## RE: 回复: 关于10M晶体老化不良问题

你好, 以下是关于TEMPH900226 ( 10M ) 晶体老化不良的相关信息回复, 请查看, 并协助回复原因, 谢谢!

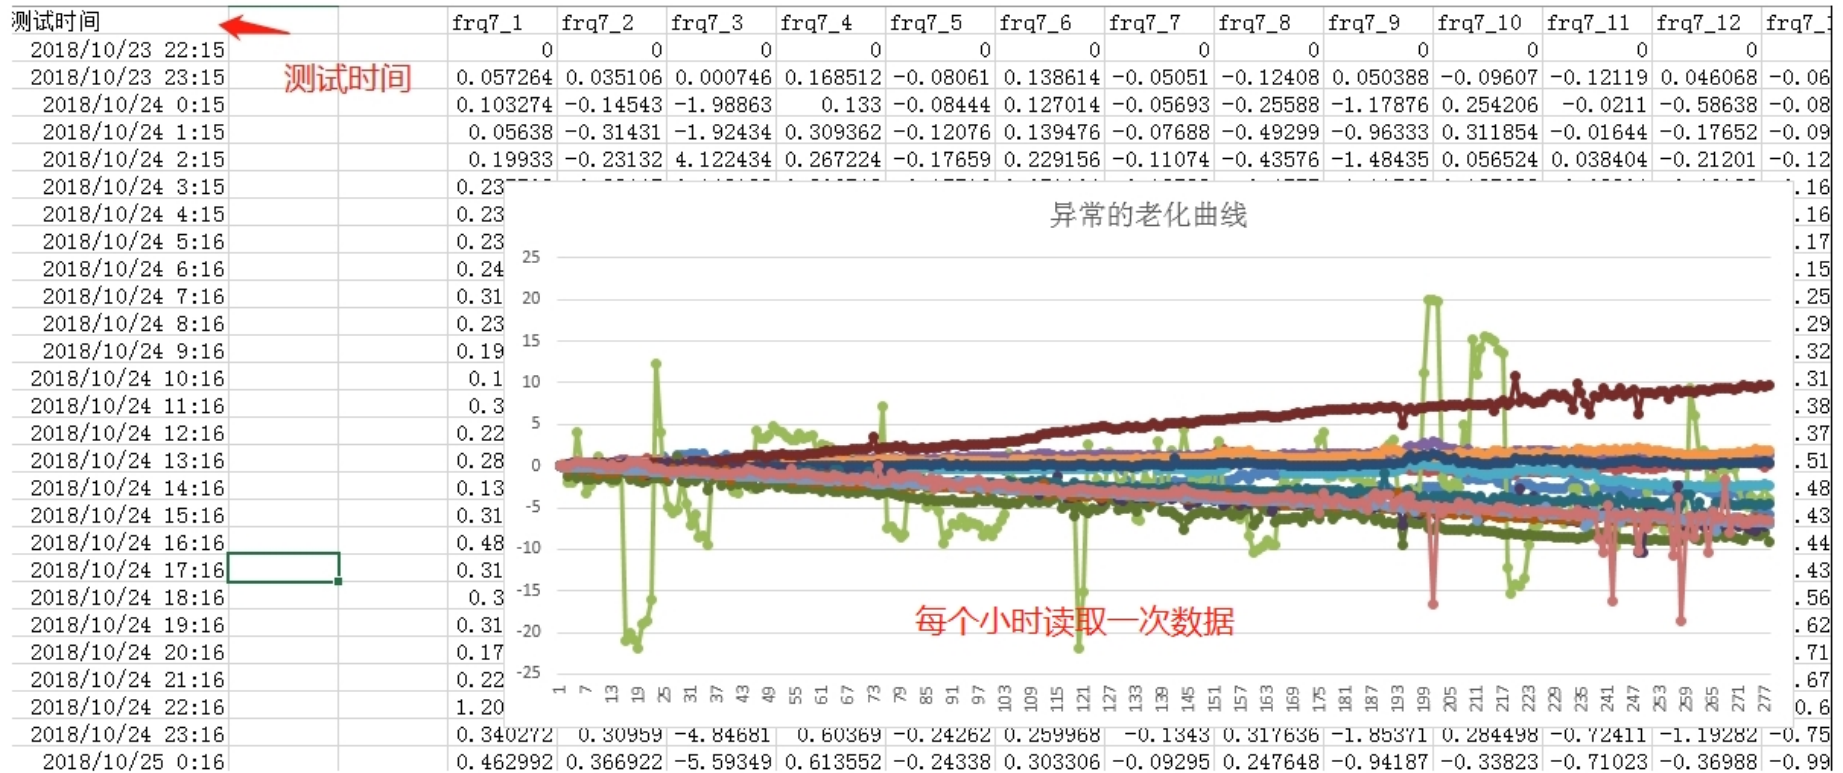
你好，附件典型不良的老化数据中有测试时间，横轴增加了时间，一小时采集一个数据，请确认，谢谢！

Thanks for the clarification. But what's the time for the "typical passed data" file. Is it also 1 hour per measurement?

异常的老化曲线

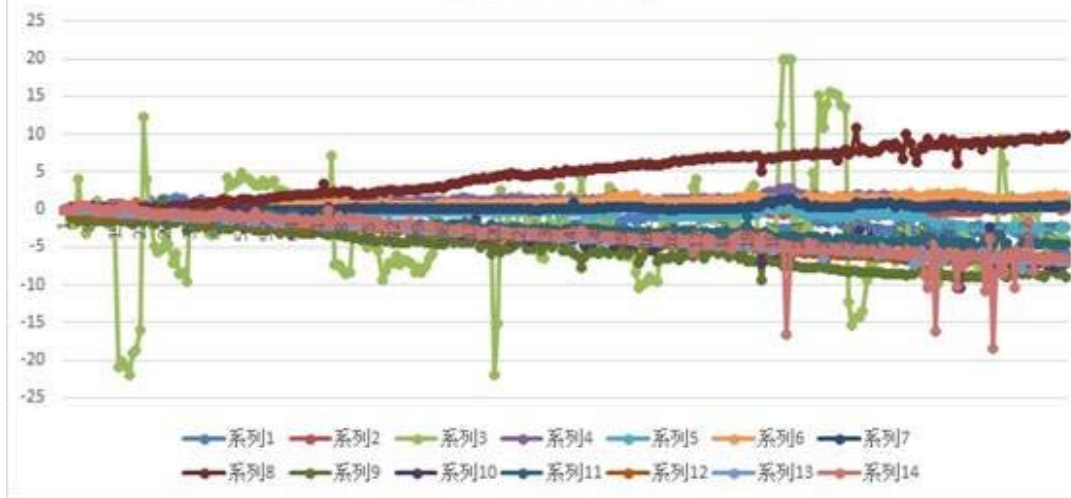
老化判定标准年老化 $\pm 50$ ppb,日老化 $\pm 0.45$ ppb,以下是合格品与异常品的老化曲线对比，合格的晶体日老化在 $\pm 0.45$ ppb范围内，而异常的晶体每天的变化超过了5ppb以上。附件是一部分的老化数据，请查看。
